AGENDA

ST. TAMMANY PARISH PLANNING COMMISSION MEETING 6:00 PM - TUESDAY SEPTEMBER 8, 2020 ST. TAMMANY PARISH GOVERNMENT COMPLEX PARISH COUNCIL CHAMBERS 21490 KOOP DRIVE, MANDEVILLE, LOUISIANA

2020-2017-FP

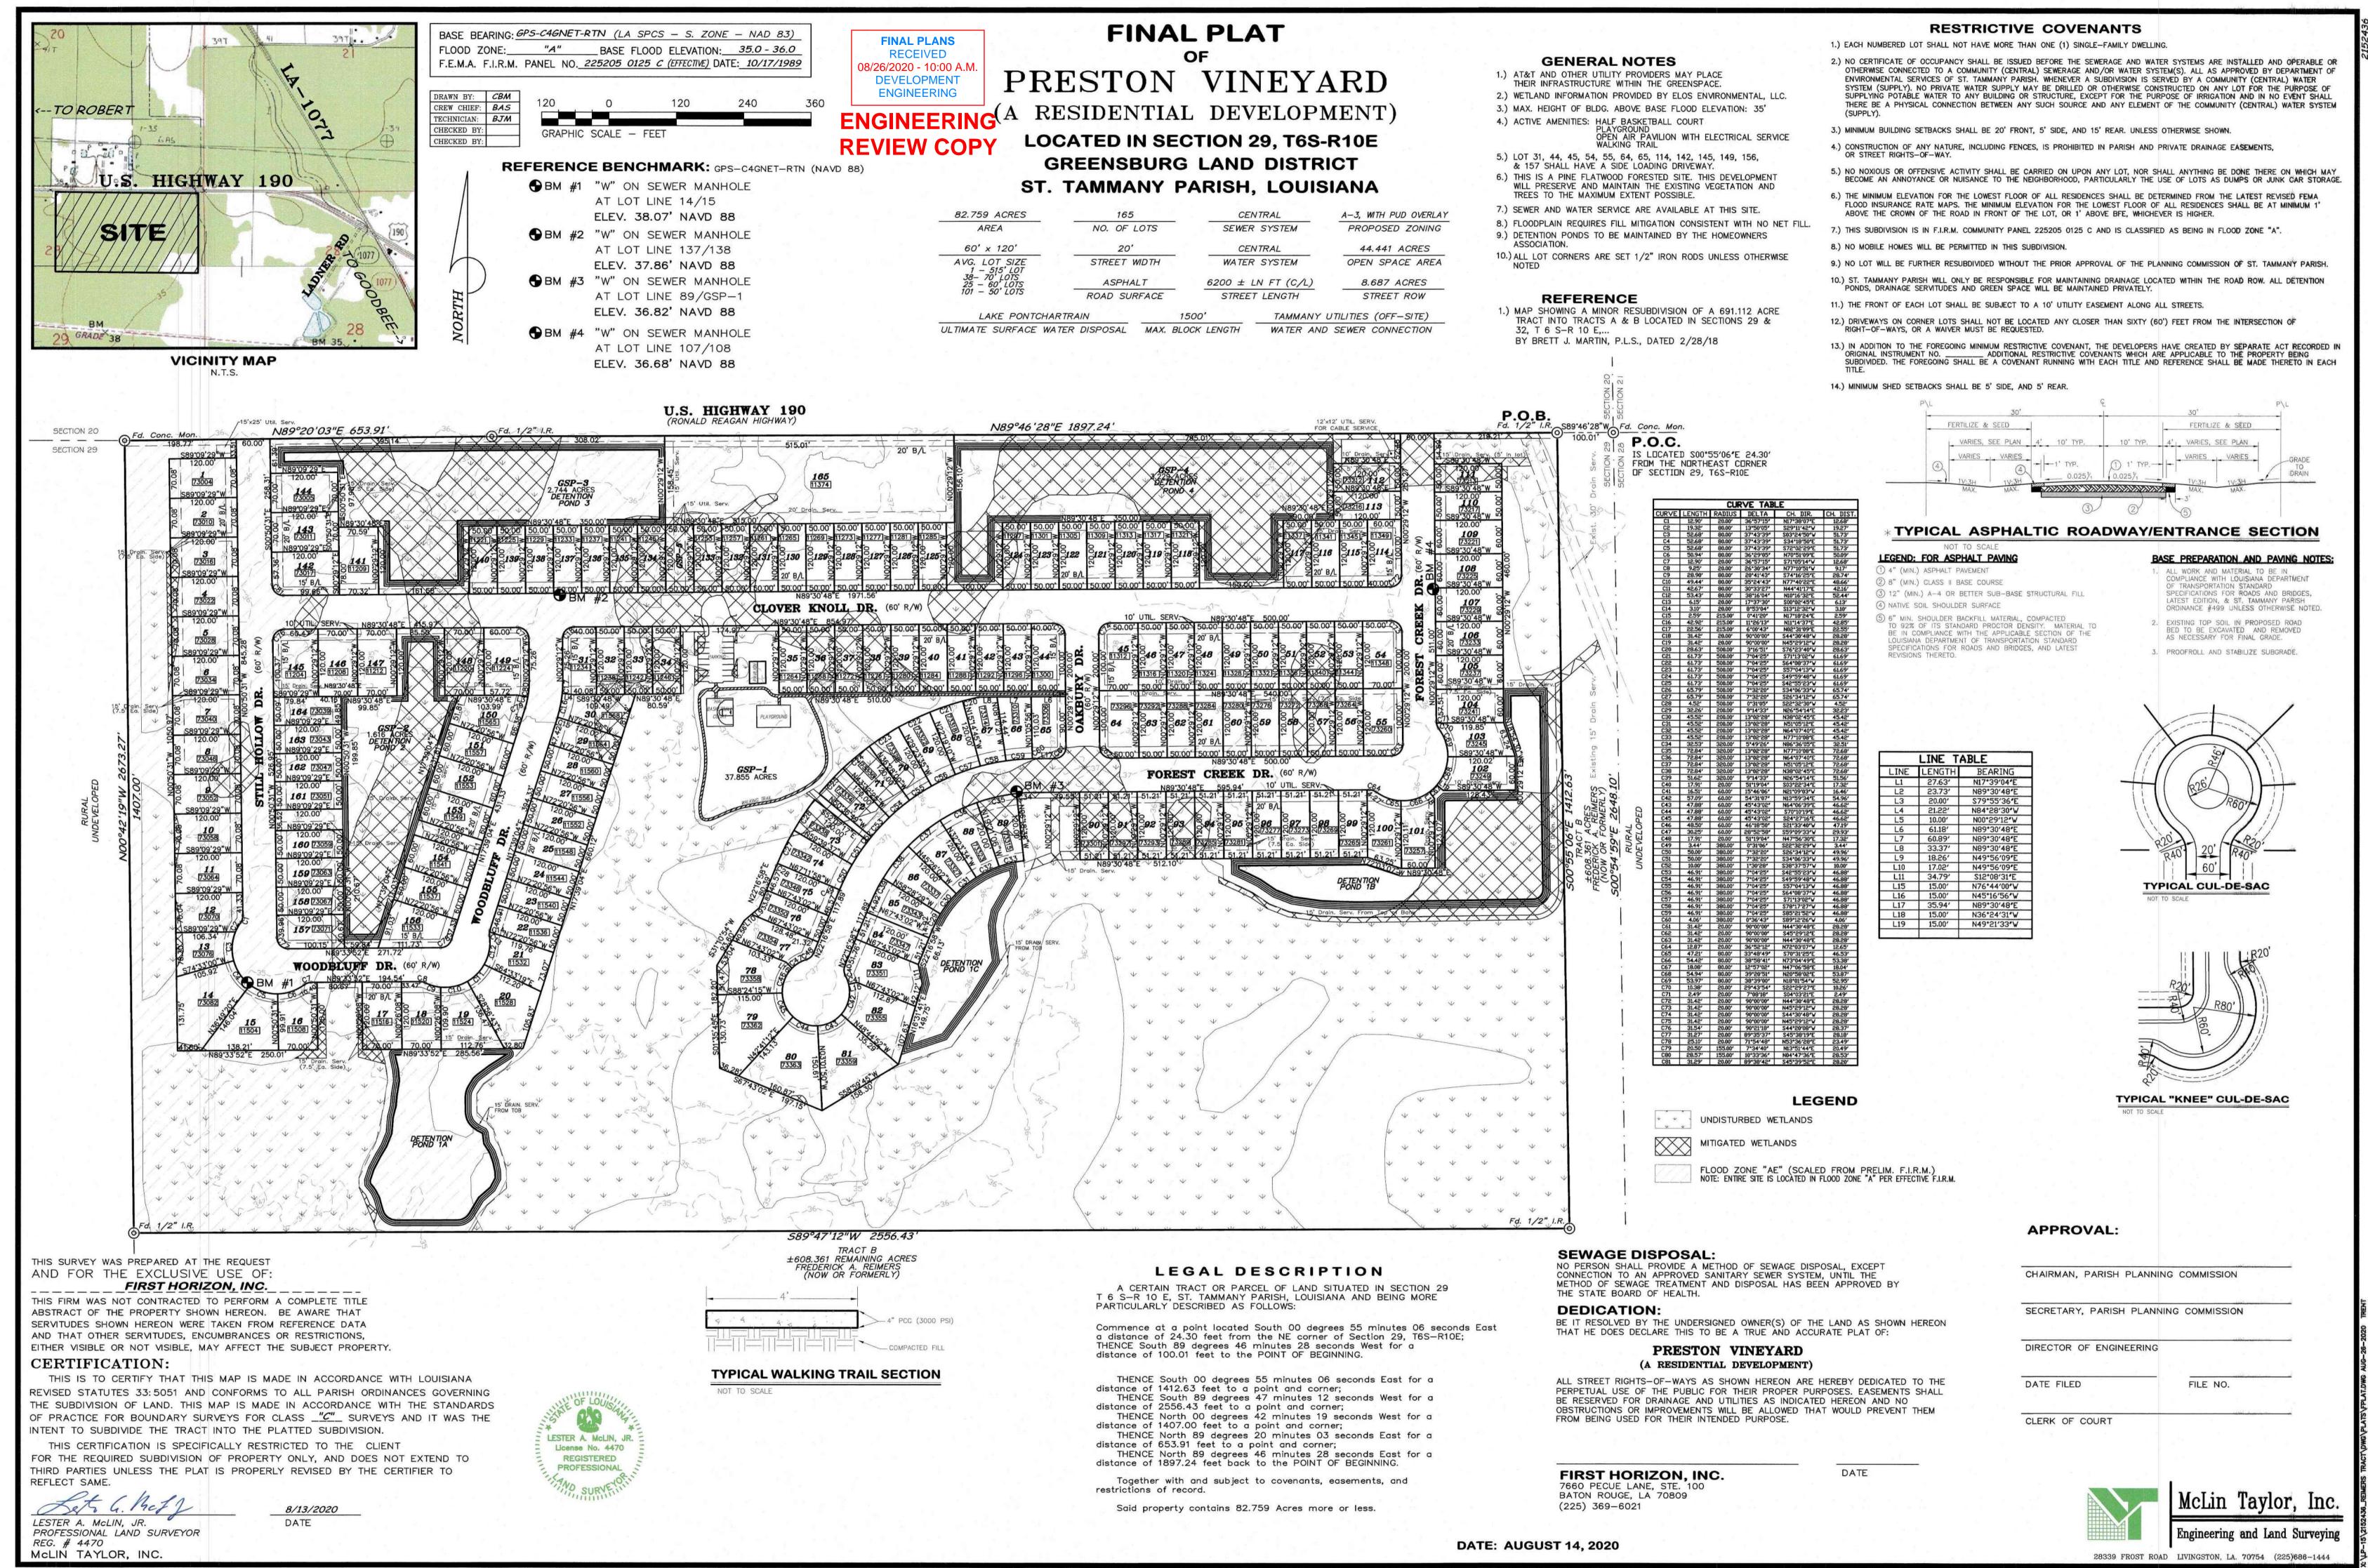
- 1. Provide Roadway Base Test Results for this development.
- 2. Provide Asphalt Test Results for the roadways within this development.
- 3. Provide utility trench bedding test results.
- 4. Provide utility trench backfill test results.
- 5. Remove all references to "Proposed" or "Required" work from all plan sheets.
- 6. The required amenities need to be installed in accordance with the approved plans.
- 7. The exposed portion of the outfall pipe for Pond 1B needs to be coated per manufacturer's specifications and the required Rip-Rap installed at the outfall.
- 8. Pond 1A was constructed as a dry detention pond which conflicts with the previously approved wet detention pond. Provide updated As-Built drawings and associated documentation reflecting the dry pond construction.

- 9. All parcels need to be individually labeled (i.e. GS-1, GS-2). Revise plat accordingly.
- 10. Revise the plat to show "Ronald Reagan HWY (US HIGHWAY 190)" because this segment of roadway is recognized as Ronald Reagan HWY.
- 11. Revise Restrictive Covenant #10 to include that the Recreation Amenities will be privately owned and maintained.

- 12. The building pad/centerline elevations shown on Sheet C-1 Drainage & Paving Plan do not match the elevations show on Sheet C-1.1 Grading Plan. Revise plans to eliminate conflicts.
- 13. The subsurface pipes between Pond 1A and Pond 2 do not provide positive flow. Verify that the invert elevations shown are correct or revise plans accordingly.
- 14. Show drainage direction arrows for all parcels on Sheet C-1.1 As-Built Grading Plan.
- 15. The crest length of the eastern weir for Pond 1A exceeds the approved 5 ft. crest length. Revise the crest length to conform to the approved plans and hydraulic analysis, or provide updated documentation to verify constructed crest length conforms to St. Tammany Parish Ordinances.

- 16. Provide label and dimensions for the required lift station servitude to verify the minimum 25' x 25' servitude is provided. Update the Final Plat accordingly.

- 17. Provide As-Built slopes for all gravity sewer mains.
- 18. Provide clarification that the end of the water main at US Hwy 190 and Still Hollow Drive is restrained, and add an end treatment detail to the plans.

- 19. State the water main material type for the water lines bored under US Hwy 190 and include the water main casing material, if installed.
- 20. Update the As-Built Water Plan to show the size of the water line installed to service Lot #165, and state if a water valve was installed at the 12" water line tie-in point.

- 21. Show the 15' utility servitude lines running through GSP-5 on Sheet C-3 As-Built Water Plan.
- 22. Provide a water and sewer Letter of Capacity for this development from Tammany Utilities.
